ANSI/TPI 1-2014 is referenced in both 2015 and 2018 International Building Codes. This article summarizes the significant changes made between the ANSI/TPI 1-2007 and ANSI/TPI 1-2014 that affect the truss designs.

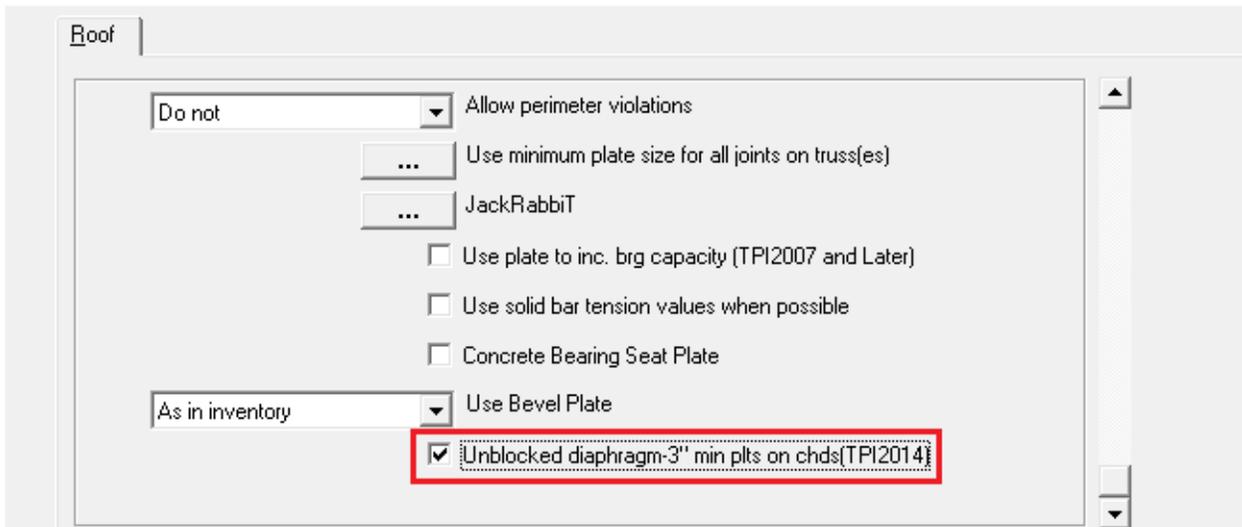
To indicate the new method of checking deflection with ANSI/TPI 1-2014 the Engineering Truss Drawing shows Vert(CT) (the Creep Total vertical deflection) instead of Vert(TL) (the Total Load vertical deflection). The horizontal deflection also changed to show Horz(CT) (the Creep Total horizontal deflection) instead of Horz(TL) (the Total Load horizontal deflection).

Solid Bar Plating.

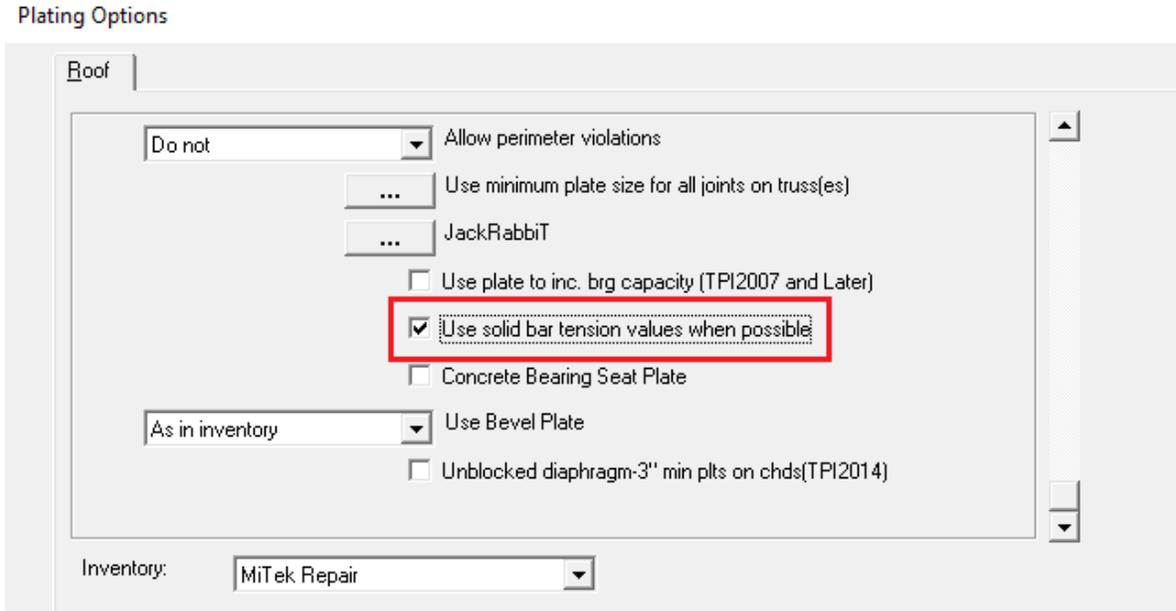
ANSI/TPI 1-2007 required that the tension value for connector plates be established with the minimum net section over the splice. MiTek established our ICC-ES research reports with an additional alternative value for when the solid section of the plate was over the splice. This method has now been added to ANSI/TPI 1-2014, but with more restrictive requirements than MiTek had with our design method.

Special measures should be taken to ensure that the shop understands the high degree of accuracy required on splice joints when solid bar tension values are used. ANSI/TPI 1-2014 only allows for a 1/16" positioning tolerance, making it very difficult to use this option in production. Although we do not recommend using this feature as a rule, as it requires stringent quality control, it may allow you to plate some joints that you could not otherwise. This setting can be activated in Edit > Plate Options:

New Moment Check for Floor Plate Splices.

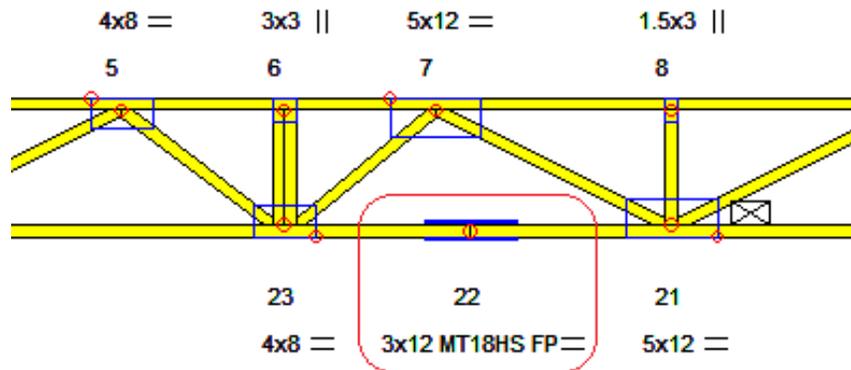
The new section 8.7.2 Design of Splice Joints with Plates on Top and Bottom was included to account for moment on flat chord (floor truss) splices. It is possible that designers may see some higher gauge plates at top and bottom chord splices of floor trusses.

Bearing perpendicular to grain.

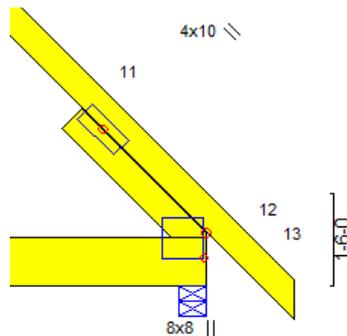
A 0.3 factor was added to one of the calculations for compression stress perpendicular to the grain ($F_{c\perp}$) in the ANSI/TPI 1-2014. This limit may affect deeper members, like 2x8 and larger depths that are not supported at intermediate points along their depth. Full height blocking reinforcement may be required to prevent buckling at bearings where it previously was not required based on the ANSI/TPI 1-2007 calculation. If full height blocking is required, a note displays in Notes section on the Engineering Truss Drawing:
